**Coal Combustion Residue Impoundment
Round 9 - Dam Assessment Report**

H. B. Robinson Power Station

***Progress Energy Carolinas
Hartsville, South Carolina***

Dewberry & Davis, LLC
Fairfax, Virginia

Exhibit 01: Typical Cross-Section of Dike (before 2002 dike raise).

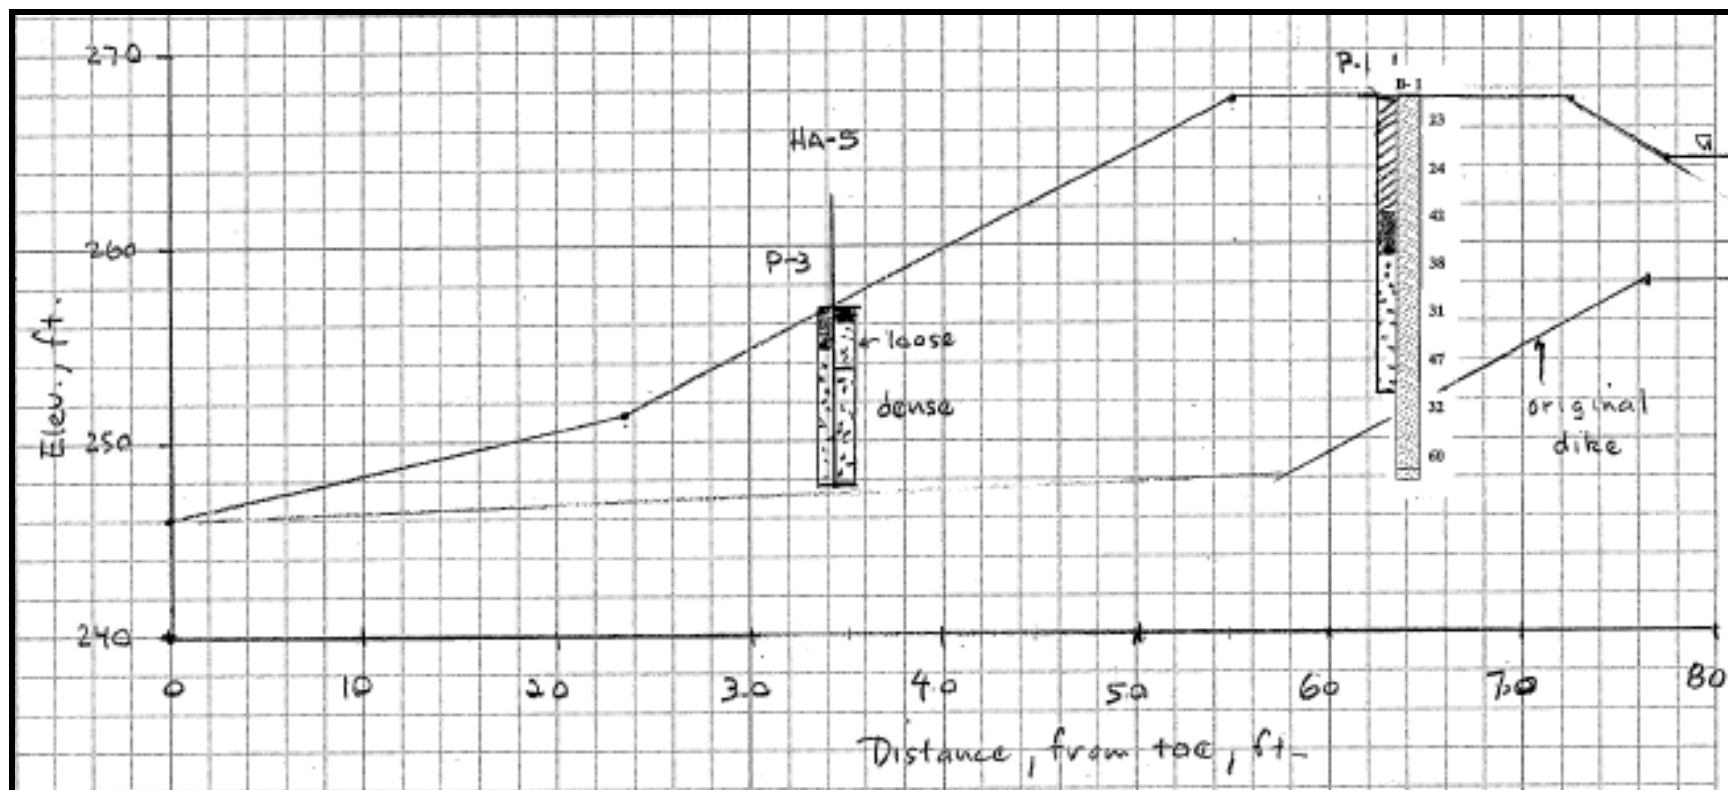
The dike was constructed across a natural valley area. A finger dike was constructed to lengthen the retention time. According to the cross-section detail shown on Exhibit 6 of Doc 03 in Appendix A, the original crest of the dike was at elevation 259 feet. Top of the overflow riser structure prior to the 1982 dike modification was at 254.0 feet. Approximate height of the dike was 13 feet.

In 1982, the dike was raised 7 feet to provide an additional 10 years of storage capacity. The crest elevation was raised to 266.0 feet (see Exhibit 6 of Doc 03 in Appendix A). The design and construction of the raised embankment was by Carolina Power & Light Company. The overflow structure is shown on the original plans to be a 36-inch diameter RCP riser with a top elevation of 264.0 feet, up from the original 254.0 feet. (This 36-inch riser is a discrepancy with the 48-inch riser indicated in the design of 2002 dike raise.) A previously existing 24-inch diameter catch basin riser extending down to the outlet pipe was abandoned in place and a new 24-inch catch basin riser was constructed further downstream along the outlet structure. The outlet pipe is shown on the original plans to be a 36 inch diameter RCP extending to the discharge canal.

Exhibit 02: Outlet Structure (before 2002 dike raise).

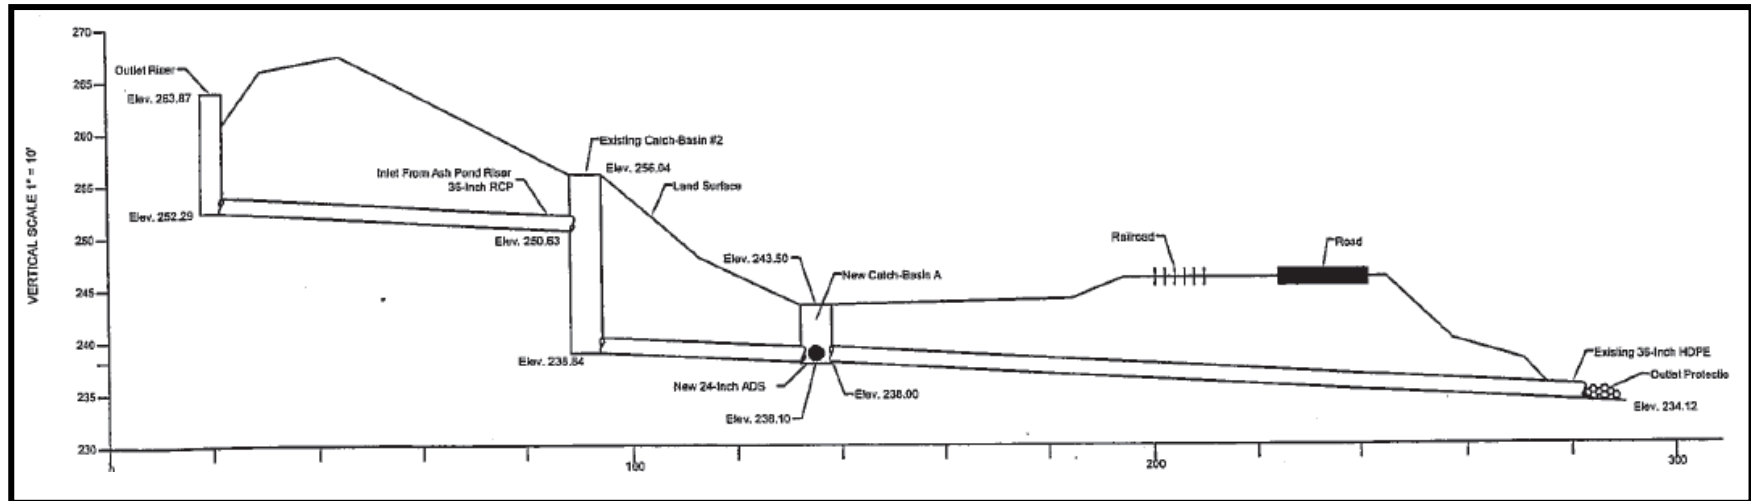
The description of the management unit provided by the owner was overall an accurate representation of what Dewberry observed in the field. However, there appears to be a discrepancy concerning the size of the overflow riser between what is shown in original plans (36-inch diameter RCP) and what is shown in design drawings for the last dike raise in 2002
